CULEBRA MEDICAL OFFICE
 9026 CULEBRA #105
 SAN ANTONIO, TX 78251

ARCHITECTURAL FLOOR PLAN

A1.0

1 FLOOR PLAN
 SCALE: 1/8" = 1'-0"

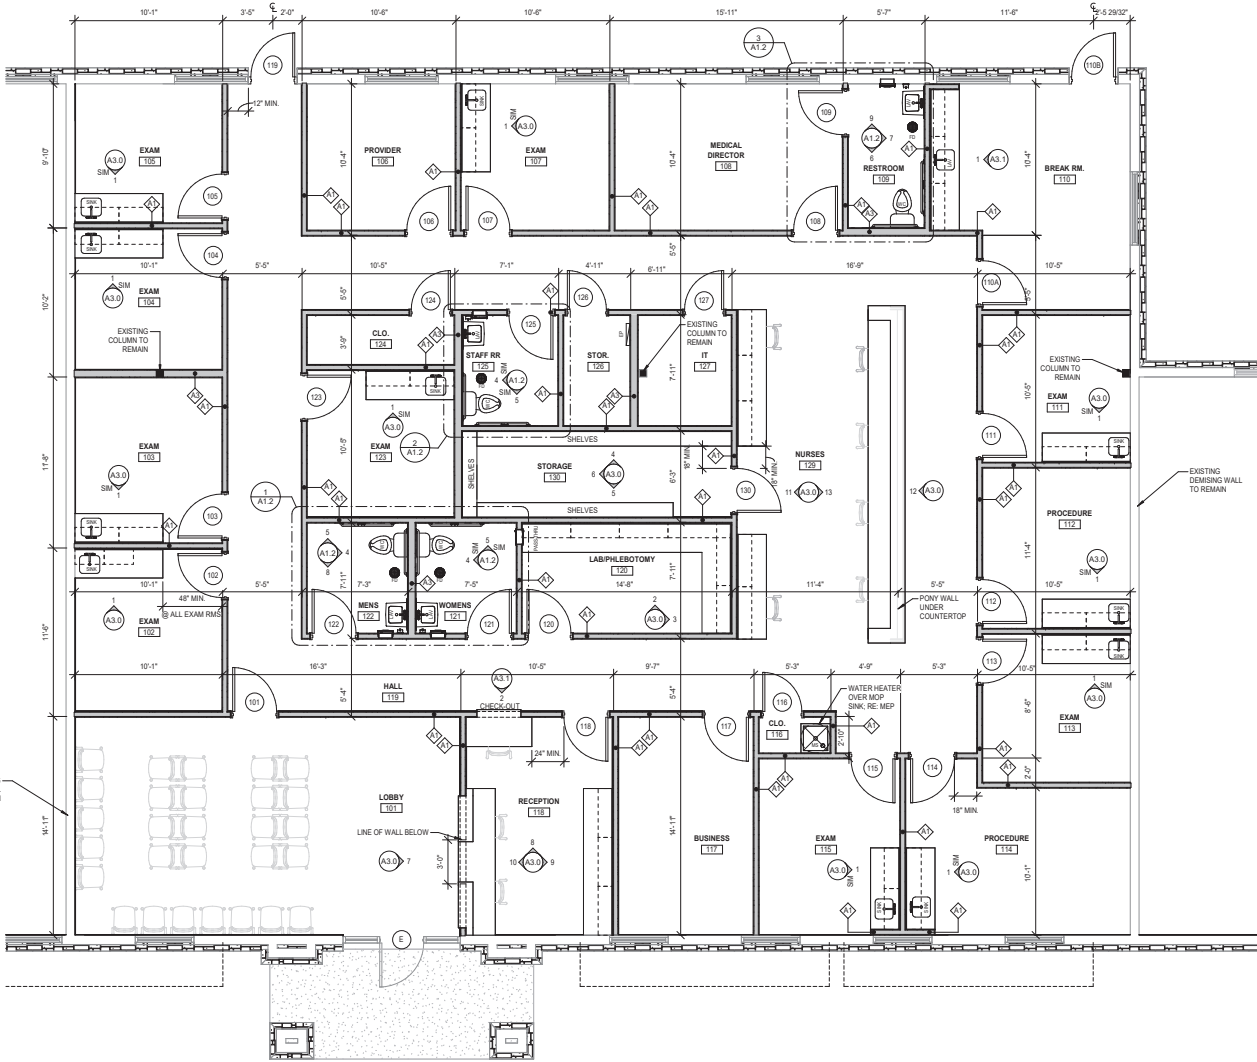
1. Building Approval Comment: All work to comply with 2024 I-codes. Inspector to field verify doors and hardware comply with IBC Sec. 1010, glazing per IBC Sec. 2409, and concrete foundation code per ISCC4 and IBC Ch. 18 & 19.
